Subject: Recall Campaign No. 05V-566

# Service Bulletin

**SAFETY RECALL CAMPAIGN**  
ALL 2005 AND CERTAIN 2006 VL800/T/Z BOULEVARD C50/T  
& VZ800 BOULEVARD M50 MOTORCYCLES  
IGNITION SWITCH INSPECTION/REPLACEMENT

**SUBJECT:** RECALL CAMPAIGN - IGNITION SWITCH INSPECTION/  
REPLACEMENT

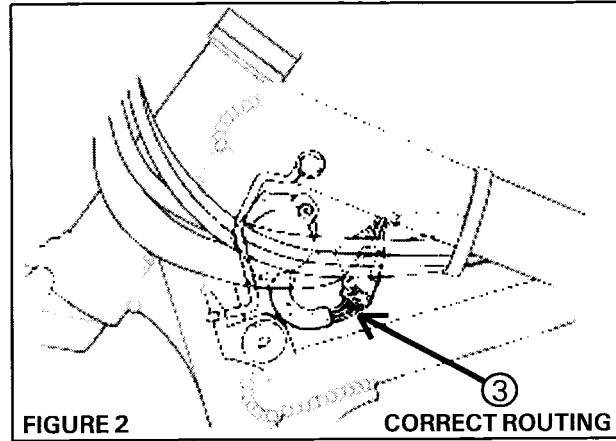
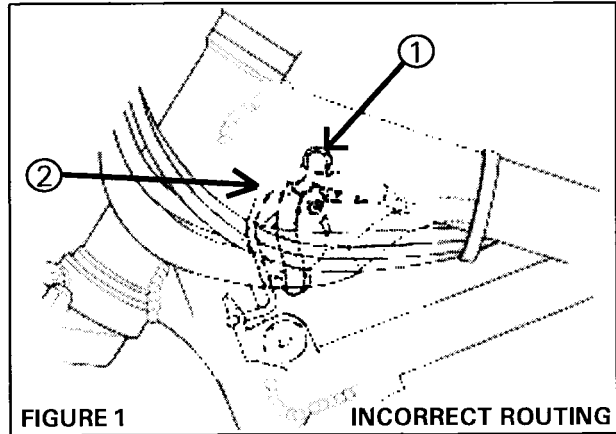
The ignition switch wiring harness may have been improperly routed at the time of production. If the wiring harness is not routed properly, it can rub against the clutch cable/throttle cable. Continued rubbing may eventually lead to a short circuit which may cause the engine to stall and/or the lights to go out. If the engine stalls the rider may be unable to restart it. This can increase the risk of a crash.

3. Remove ignition key and right side frame head cover. Remove left side frame head cover.
4. Inspect the ignition switch wiring harness ③ routing. If correct, re-install the frame head covers, fuel tank and front and rear seats. Proceed to Step 7.
5. If routing is incorrect, remove guide bolt ① and guide ② only. Inspect and re-route wires as shown in Figure 2.

If the protective covering over the ignition switch sub-harness is cut and the insulation of the lead wires is cut and/or abraded, replace the ignition switch and lock set. (Refer to VL800 Service Manual page 8-29 and VZ800 Service Manual page 9-35 for ignition switch replacement).

If the wire insulation is not cut and only the outer protective covering is damaged/cut, wrap the sub-harness with several wraps of electrical tape. In addition, if the clutch cable/throttle cable is damaged replace as necessary.

6. Re-install the cable guide, frame head covers, fuel tank and front and rear seats.
7. Turn on the ignition switch to confirm all of the electrical components are functioning properly (lights are working, engine starts and runs, etc.). Test ride the motorcycle.
8. Place an identification punch mark on the frame just after the Vehicle Identification Number per Figure 3 to confirm that the recall service has been completed. The VIN is located on the right side of the steering head pipe.
